828-003-14

ADDENDUM NO. 2

**Centenary United Methodist Church
Fire Sprinkler / Fire Alarm Life Safety Improvements**

Centenary United Methodist Church
Fire & Life Safety Improvements
Beatrice, Nebraska
TCEP No.: 828-003-14

Addendum #002
Supplemental Drawing: SDE-001
Revision of Sheet: E0.00
Date: December 08, 2014

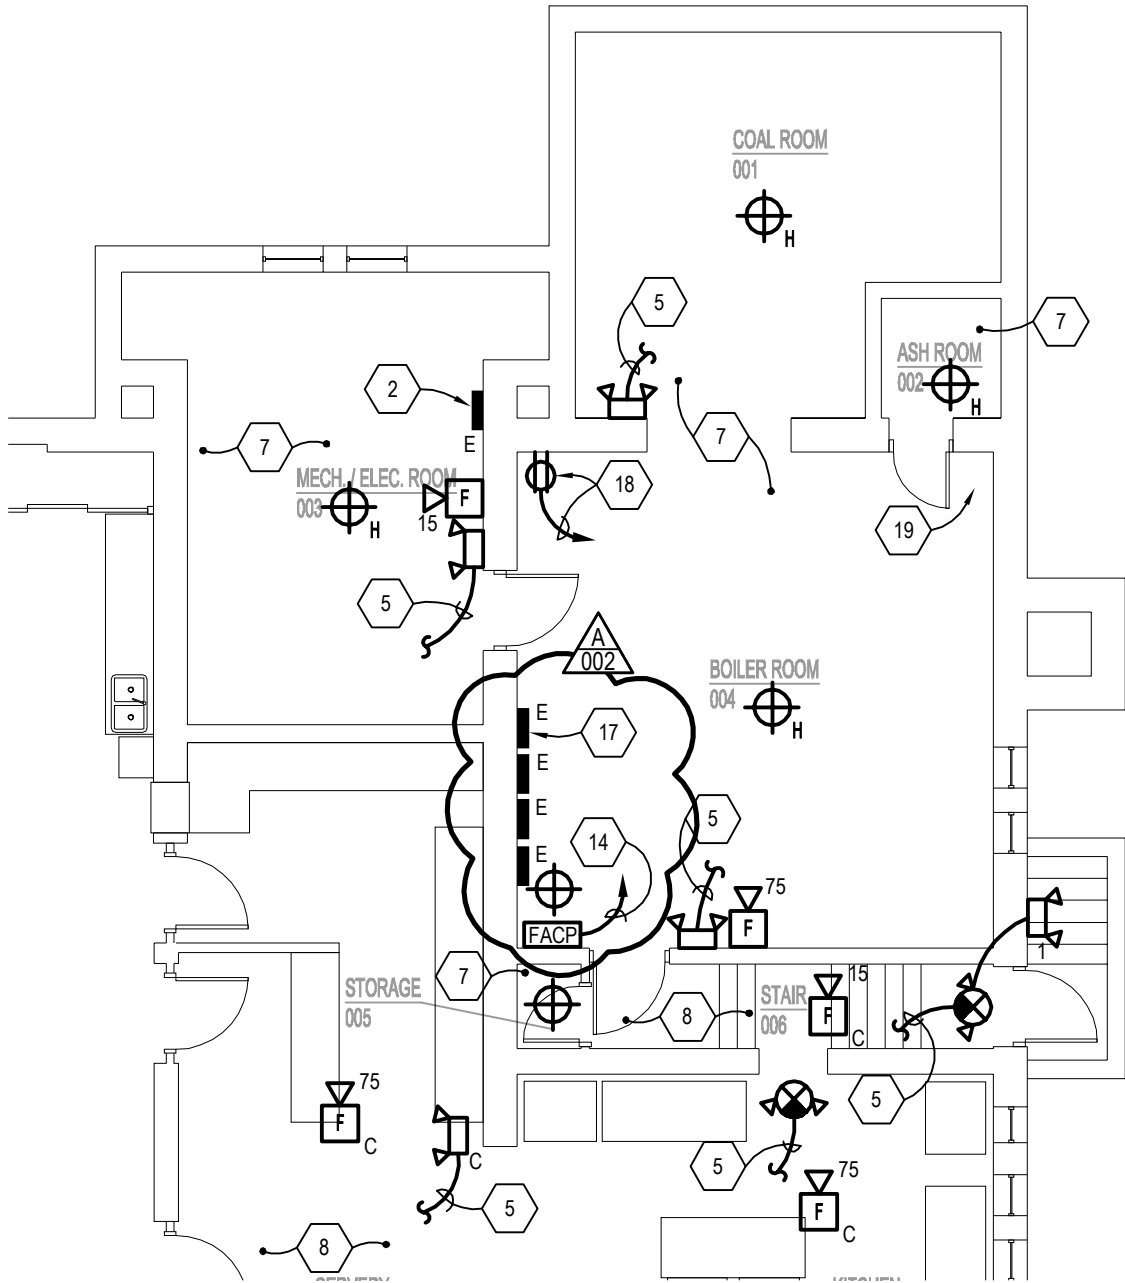
- Item 2-16: Sheet E0.00 – Electrical Symbols Legend, Abbreviations & General Notes**
Add the 'Lamp Replacement Schedule' to this sheet. See the attached Supplemental Drawing SDE-001 for additional information.

Addendum #002
Supplemental Drawing: SDE-002
Revision of Sheet: E1.01
Date: December 8, 2014

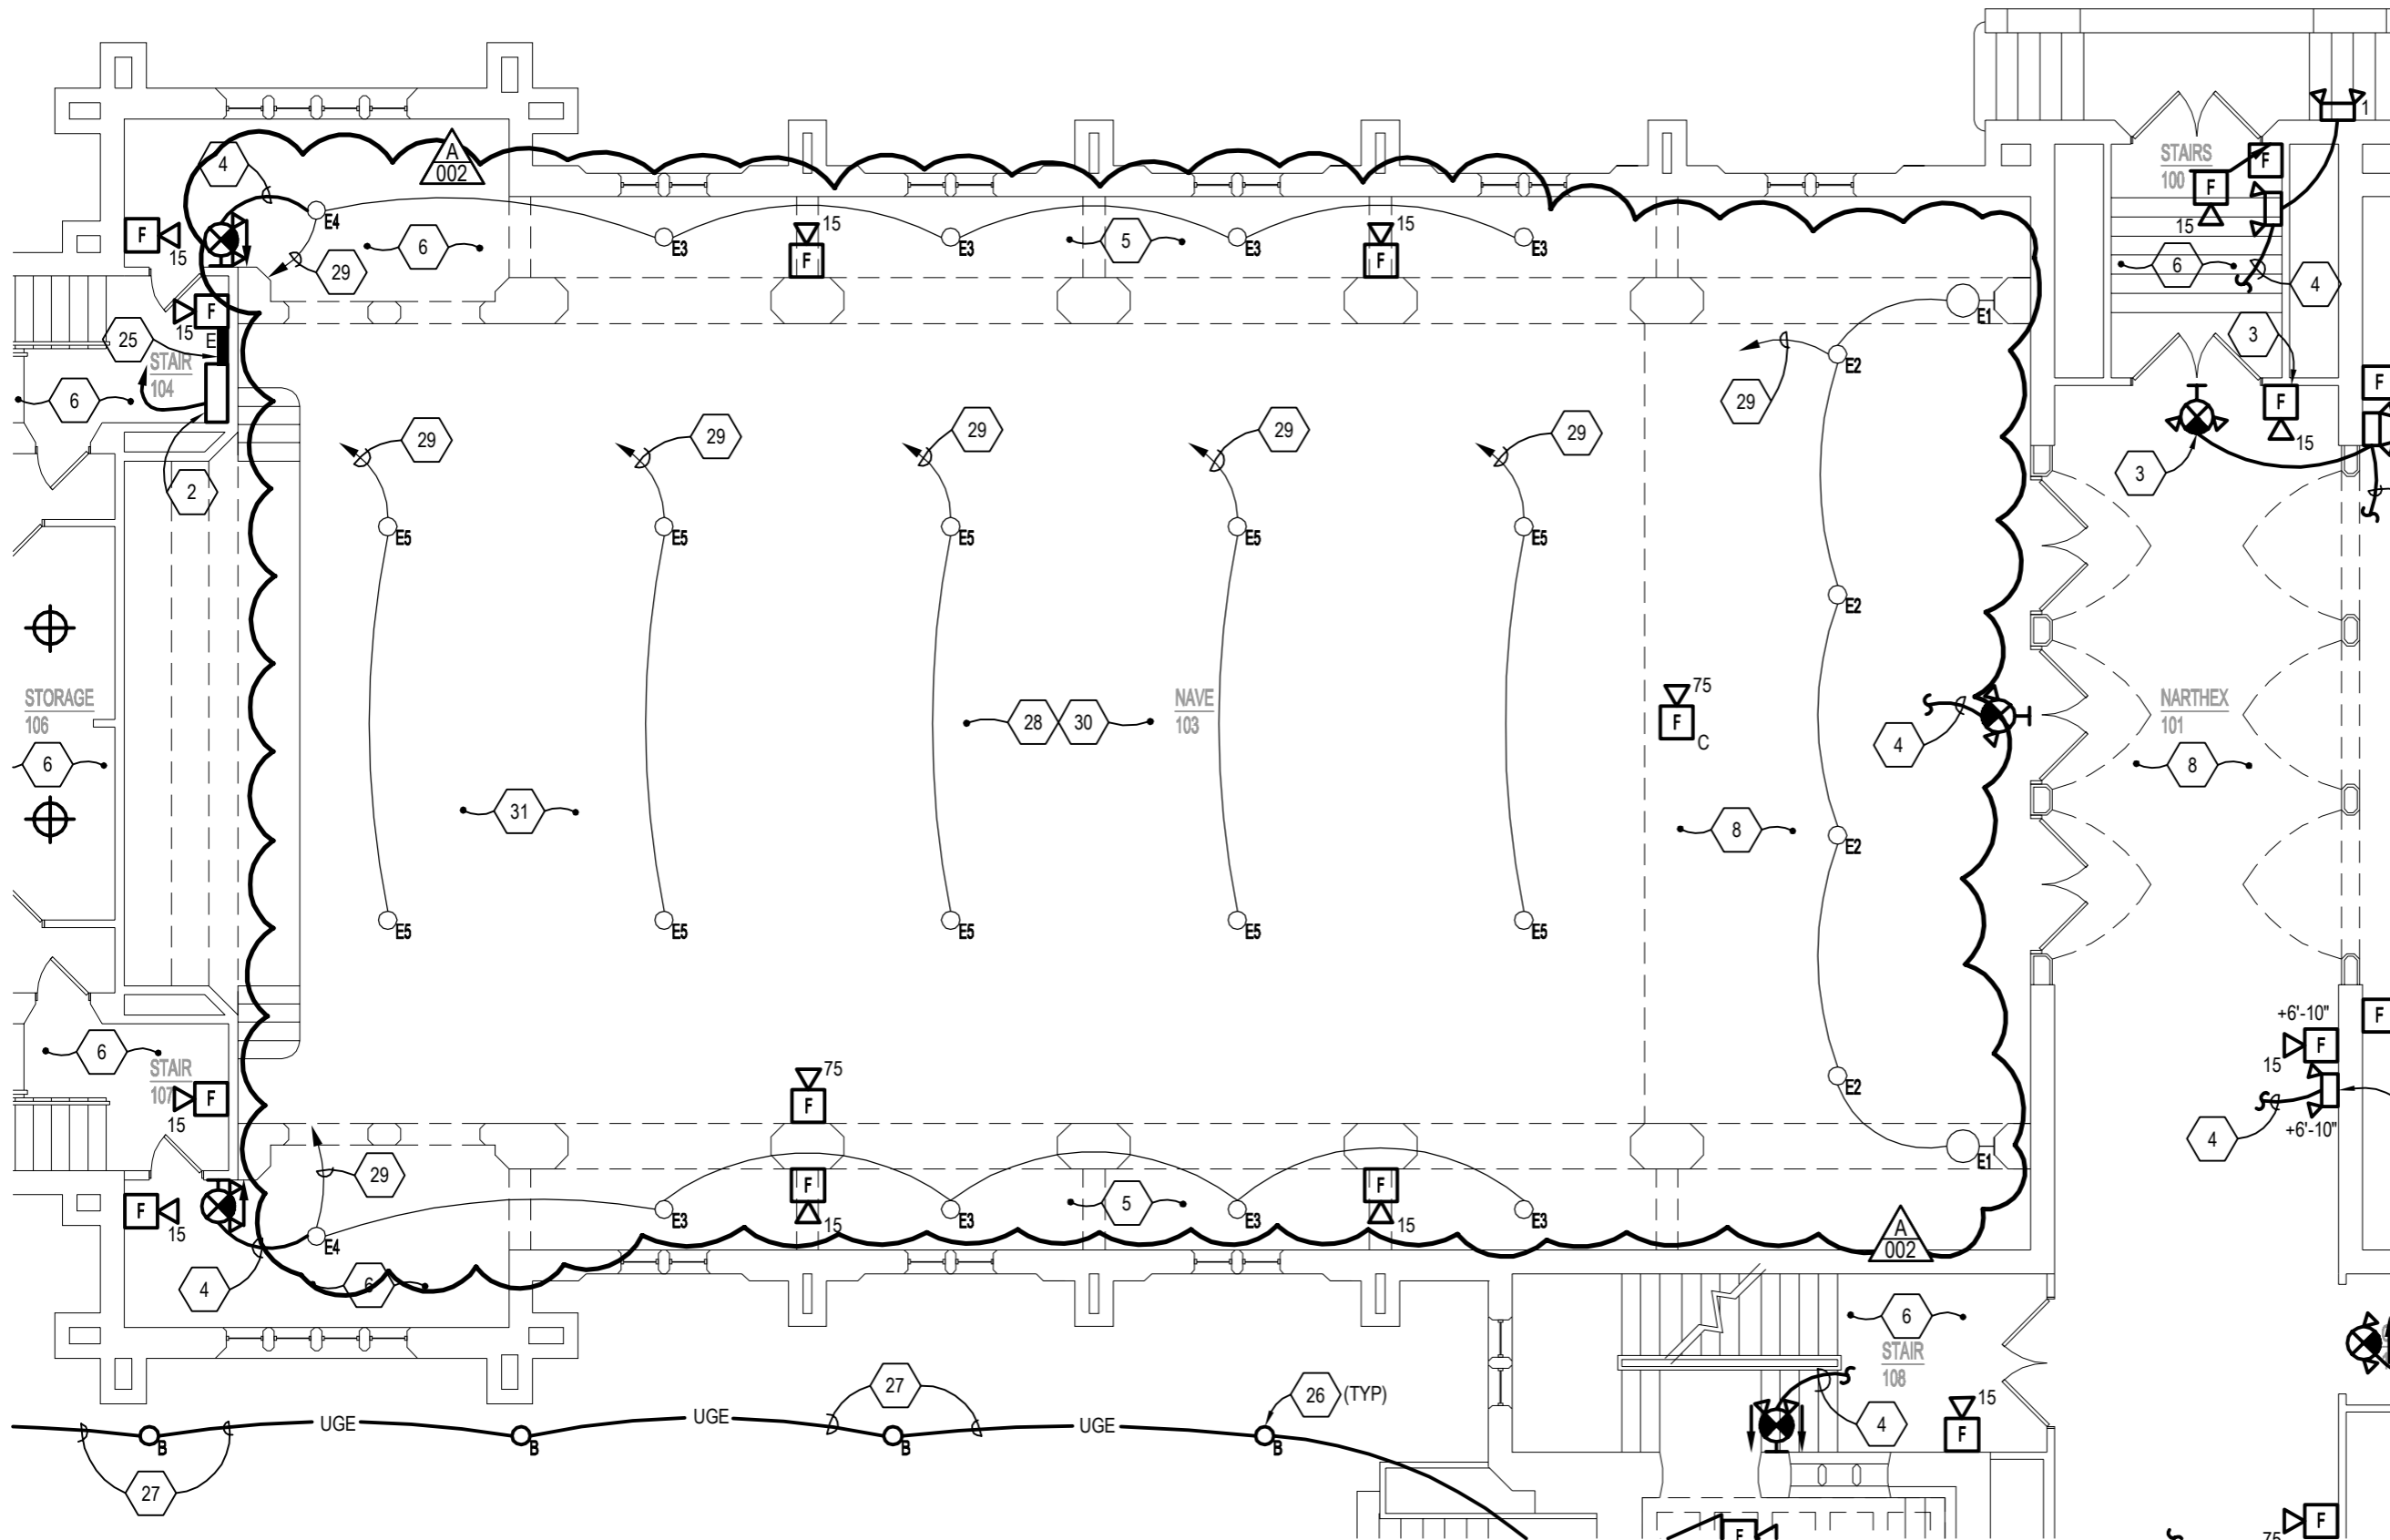
- Item 2-17: Sheet E1.01 – Lower Level Electrical Plan**
- a. In Fellowship Hall 011, remove hex note number seventeen.
 - b. The locations of the two fan coil units have changed. FC-1 is now in Elevator Lobby 113 and FC-2 is in Elevator Equipment 112.

- c. One 8 1/2" x 11" portion of this sheet is revised and reissued as a part of this Addendum. See the attached Supplemental Drawing SDE-002 for additional information.

- d. Revise 'Lower Level Electrical Plan Note' number four to read as follows: "4. If the existing emergency light is not battery back-up, or is not working correctly, then remove it and replace it with a new emergency fixture."

- e. Revise 'Lower Level Electrical Plan Note' number fourteen to read as follows: "14. Circuit to a spare 20A/1P circuit breaker in the existing panelboard 'D'."

- f. Change 'Lower Level Electrical Plan Note' number seventeen to read as follows: "17. Existing panelboard 'D', 225A, 208Y/120V, 3-phase, 4-wire."
 - g. Revise 'Lower Level Electrical Plan Note' number eighteen to read as follows: "18. Provide....Circuit to a spare 20A/1P circuit breaker in the existing panelboard 'D'."

Addendum #002
Supplemental Drawing: SDE-003
Revision of Sheet: E1.02
Date: December 08, 2014

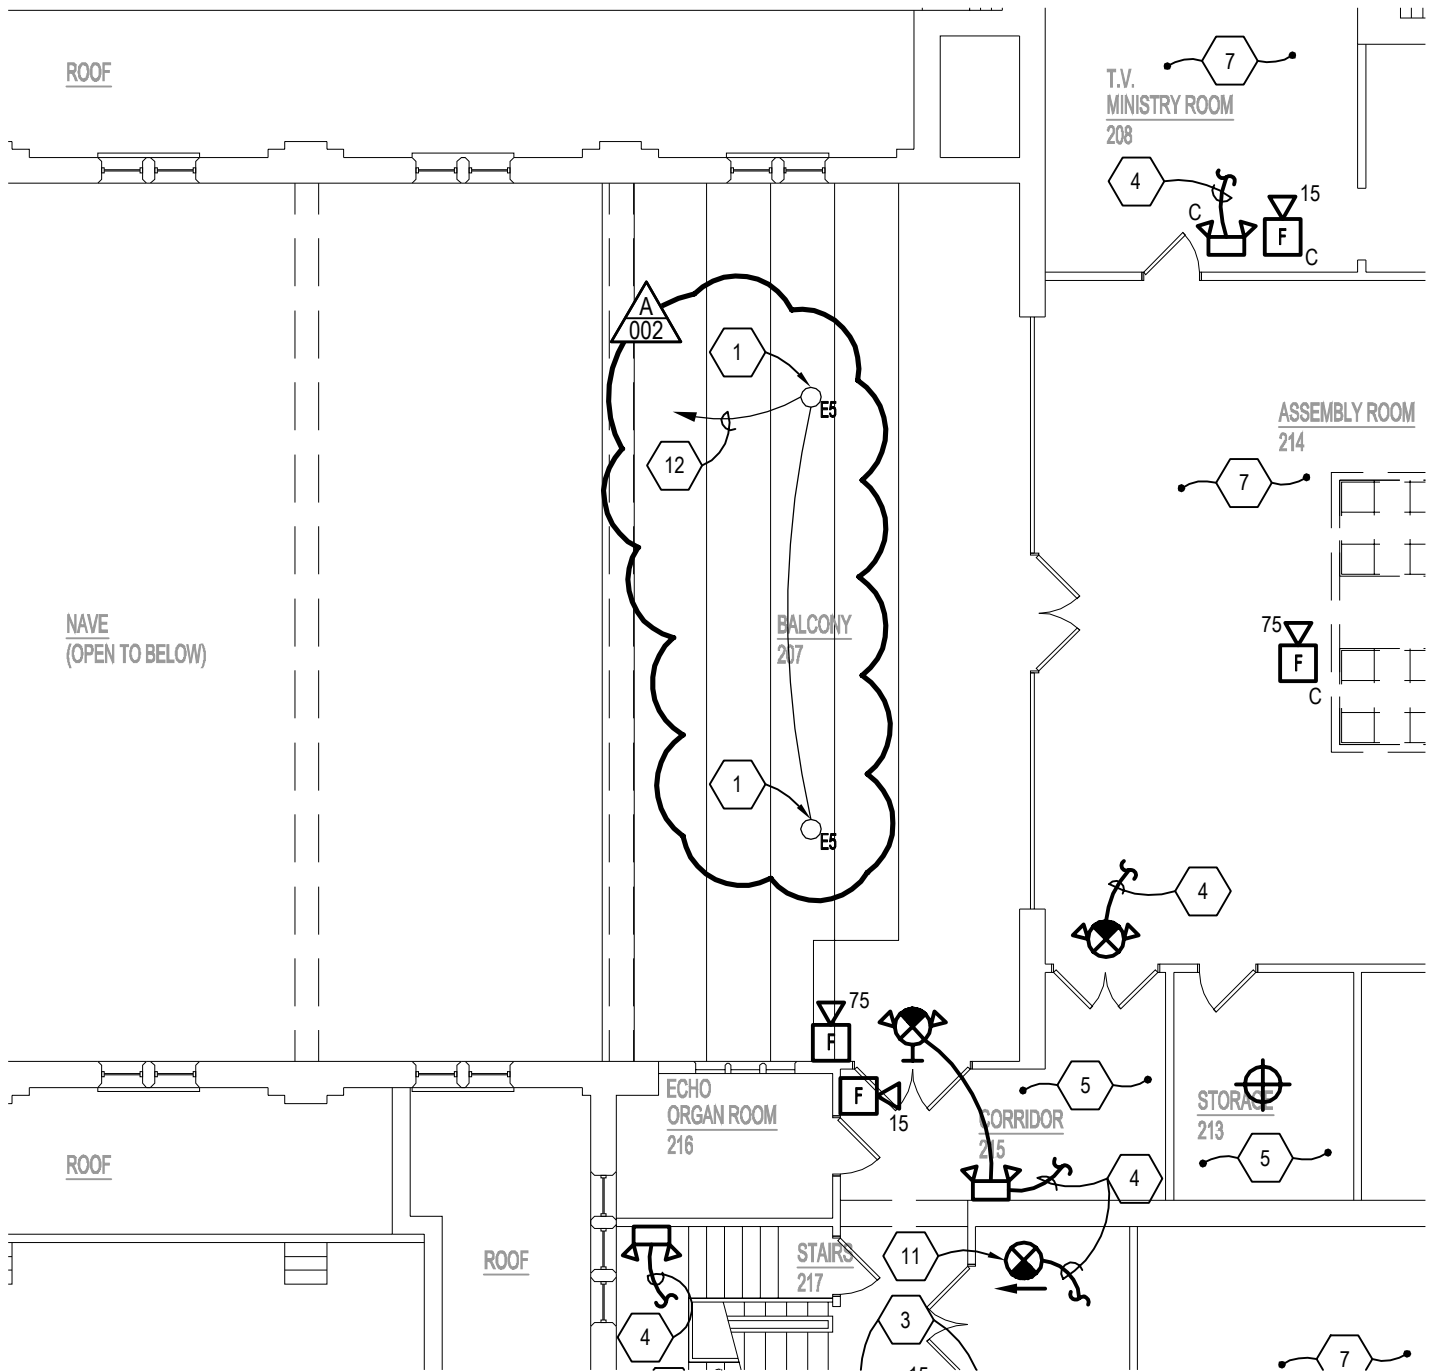
- Item 2-18: Sheet E1.02 – Main Level Electrical Plan**
- a. One 11" x 17" portion of this sheet is revised and reissued as a part of this Addendum. See the attached Supplemental Drawing SDE-003 for additional information.

- b. Revise 'Main Level Electrical Plan Note' number twenty to read as follows: "20. Heat pump...Provide a new 40A/2P circuit breaker in the existing panelboard 'D' in the boiler room 004. Locate the new breaker in an existing 2-pole spare. New breaker shall be fully compatible with the existing panelboard and shall maintain the fault current rating and UL listing of the panelboard. Route 2-#8 and 1-#10 GRND in 1/2" conduit back to the existing panelboard."

- c. Revise 'Main Level Electrical Plan Note' number twenty-eight to read as follows: "28. The light...See the lamp replacement schedule (sheet E0.00) for additional information."

- d. Add note number twenty-nine to the 'Main Level Electrical Plan Notes', to read as follows: "29. Existing circuit shall be shifted from the existing panelboard (note #25) to the inverter (note #2). Coordinate with the inverter requirements."

- e. Add note number thirty to the 'Main Level Electrical Plan Notes', to read as follows: "30. The existing sound system shall be tied into the fire alarm system so that if the fire alarm system goes off it will override the sound system."

- f. Add note number thirty-one to the 'Main Level Electrical Plan Notes', to read as follows: "31. There are two spotlight boxes in this room and each one has four 150w lamps. Replace each existing lamp with a led lamp and a 40w module, Manning cat. no. GCR-064, or equivalent. Coordinate with the existing spotlight boxes."
